## **Proposal for a Supplement to the 03 series of amendments to UN Regulation No. 79**

### **2. Proposal**

#### ACSF C – Case where the lateral movement is initiated automatically (1 Step HMI)

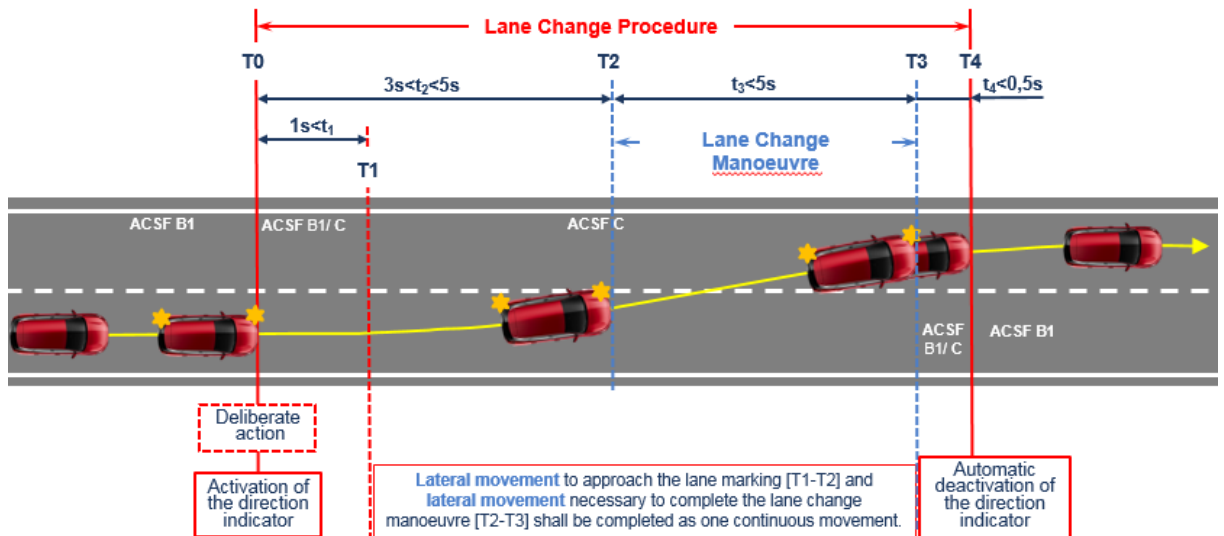
5.6.4.6.4. The lateral movement of the vehicle towards the intended lane shall not start earlier than 1 **second** after the start of the lane change procedure. Additionally, the lateral movement to approach the lane marking and the lateral movement necessary to complete the lane change manoeuvre shall be completed as one continuous movement.

~~The lane change manoeuvre shall not be initiated before a period of 3.0 seconds and not later than 5.0 seconds after the deliberate action of the driver described in paragraph 5.6.4.6.2. above.~~

**The lateral movement may be initiated automatically or by a second deliberate action of the driver, as per Annex 9.**

5.6.4.6.7. The direction indicator shall remain active throughout the whole period of the lane change manoeuvre and shall be **automatically** deactivated by the system no later than 0.5 seconds after the resumption of ACSF of Category B1 lane keeping function as described in paragraph 5.6.4.6.6 above. **Automatic deactivation by the system of the direction indicator is only required if the lane change manoeuvre is initiated automatically without a second deliberate action."**

## Annex 9 – description of lane change procedure of ACSF category C

The following drawings summarizes the requirements specified in paragraph 5.6.4.
